Response to Action Item 19-26 Section 19.1

PRA Issue List Regarding APR-1400, DCD Tier 2, SECTION 19.1

Issue # PRA-26 (AI 19-26)

**Figure 19.1-47 Total Containment Fragility Curve**

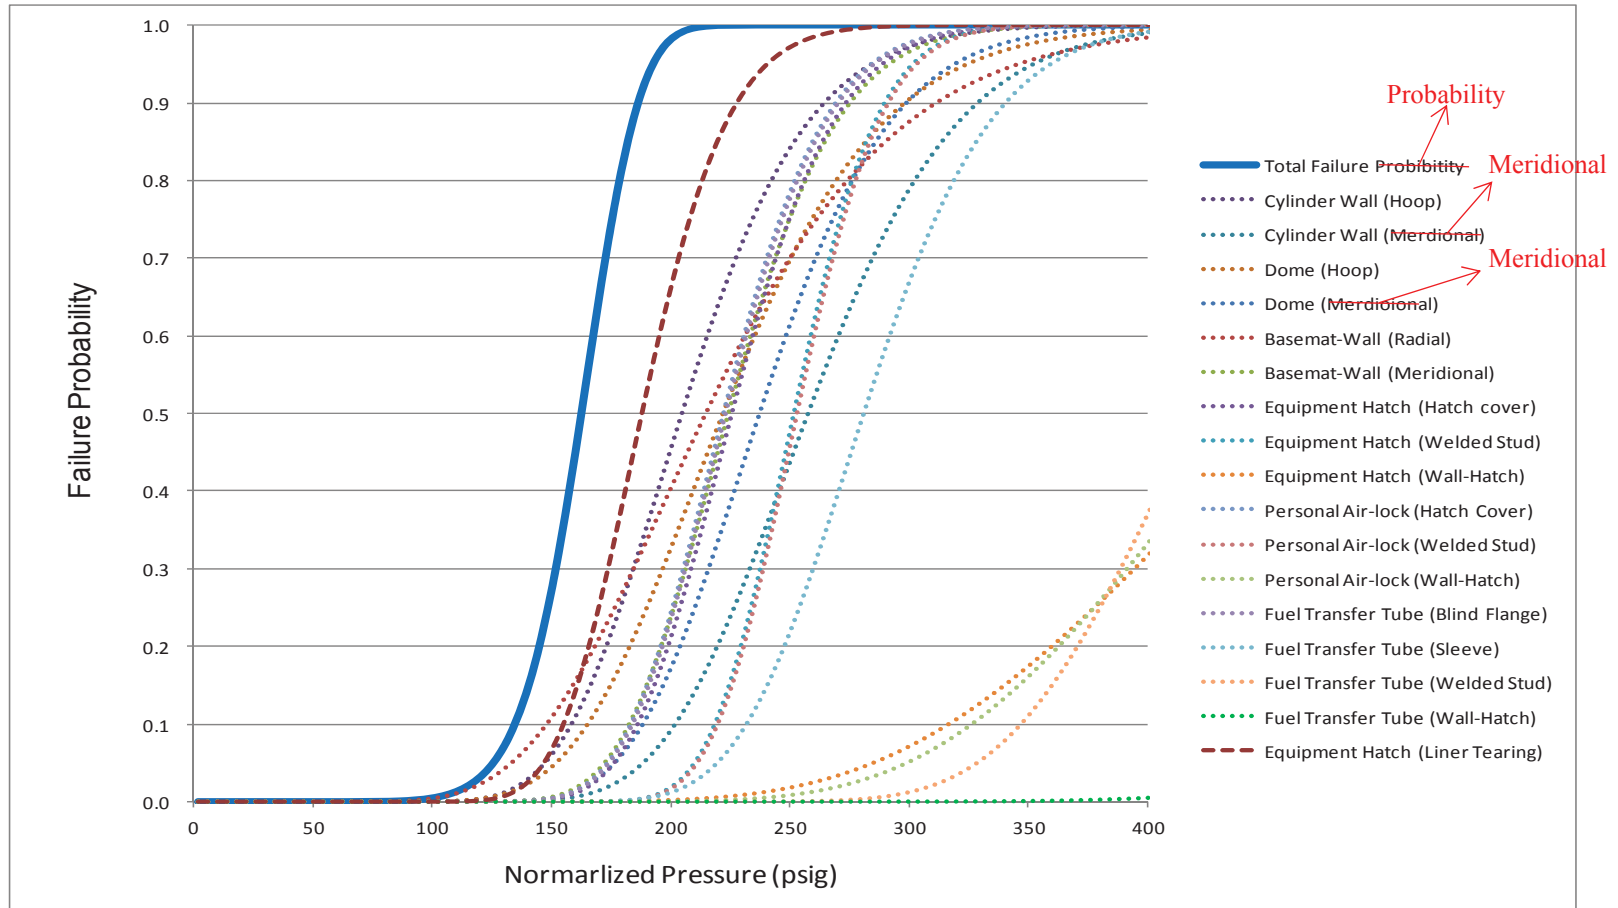
Figure 19.1-47 has numerous typos - meridional, probability, and personnel are all spelled wrong in various locations.

Figure 19.1-47 will be revised with the correction (see Attachment 1).

**Figure 19.1-44 ISLOCA Containment Event Tree**

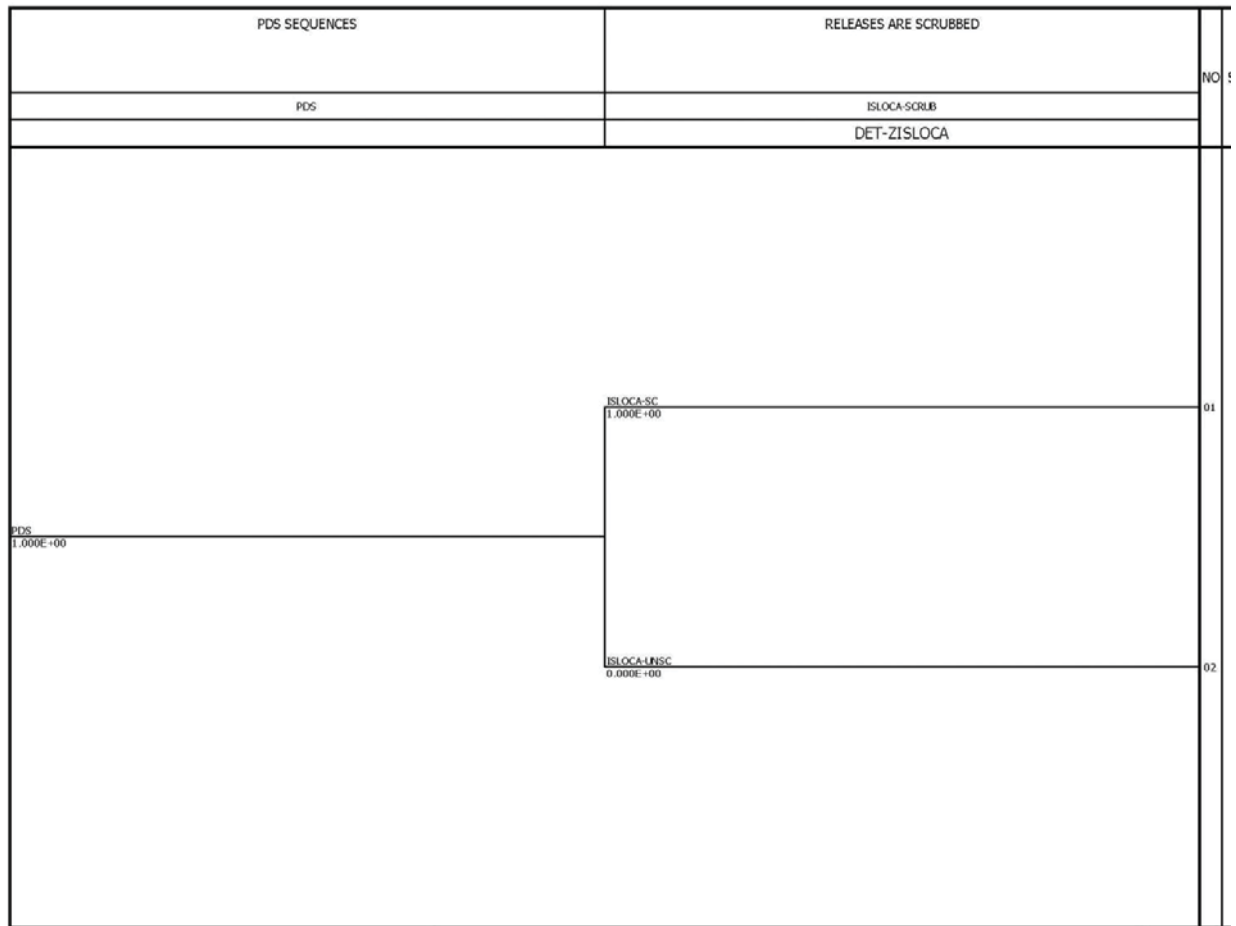
The second top event of the ISLOCA Containment Event Tree shown on DCD Figure 19.1-44 is given as "INTERFACING SYSTEMS LOCA." However, this top event does not question "interfacing systems LOCA failure" because PDSs input to this CET consists of such failure. Instead, this top event questions the availability of a water pool outside the containment for scrubbing of fission products.

As stated, the top event really questions the potential for fission product scrubbing. The text description of the top event is changed to "Releases Are Scrubbed". The text description does not alter any of the analyses.

The revised DCD Figure 19.1-44 is shown in Attachment 1. The revised Figure 5.2-2 of notebook APR1400-K-P-NR-013602-P is shown in Attachment 2.

**Figure 19.1-45 Containment Isolation Failure Containment Event Tree**

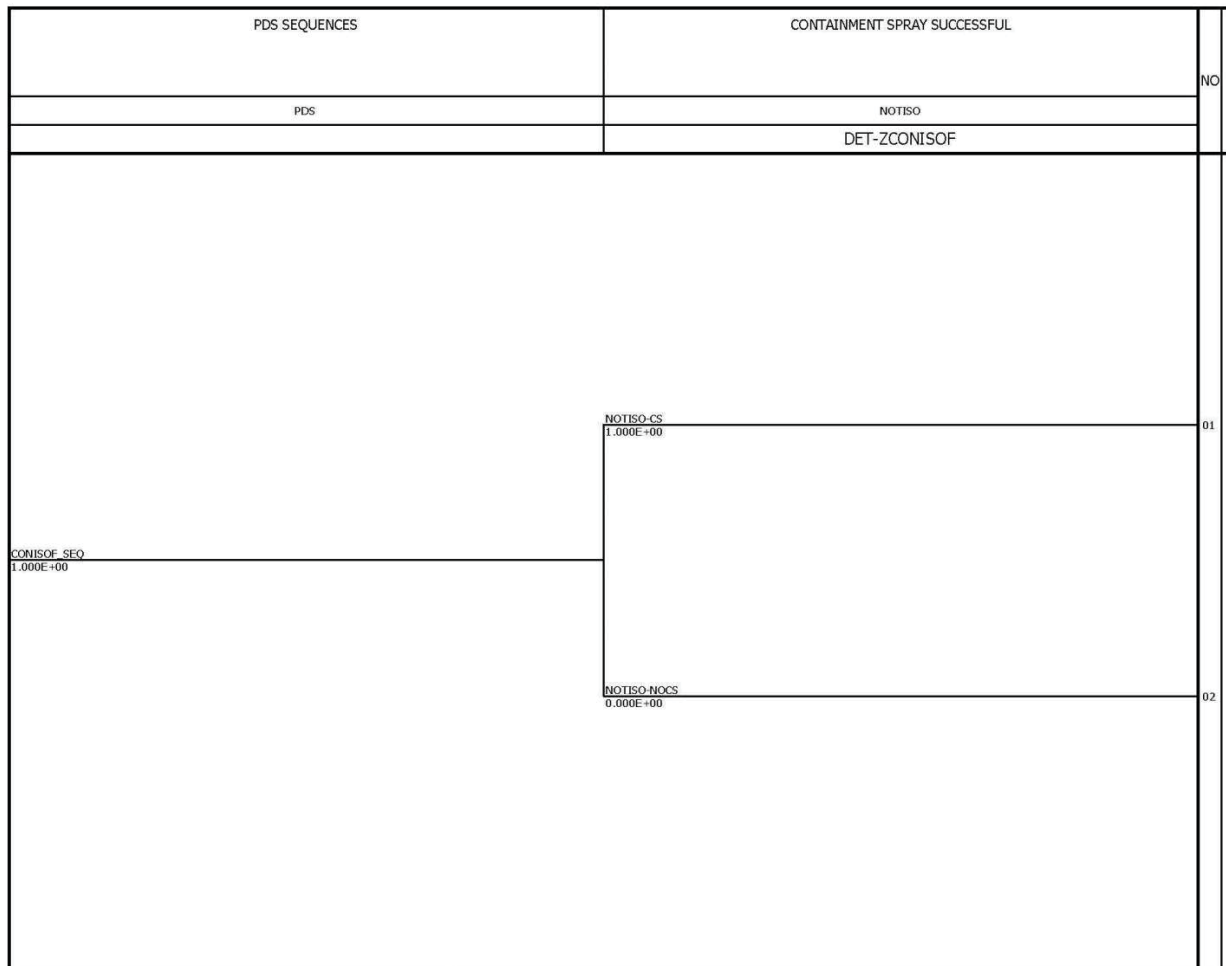
The second top event of the Containment Isolation Failure Containment Event Tree shown on DCD Figure 19.1-45 is given as "CONTAINMENT ISOLATION FAILURE." However, this top event does not question "containment isolation failure" because PDSs input to this CET consists of such failure. Instead, this top event questions the availability of containment spray for scrubbing of fission products.

As stated, the top event really questions the containment spray status. The text description of the top event is changed to "Containment Spray Successful". The text description does not alter any of the analyses.

The revised DCD Figure 19.1-45 is shown in Attachment 1. The revised Figure 5.2-3 of notebook APR1400-K-P-NR-013602-P is shown in Attachment 2.
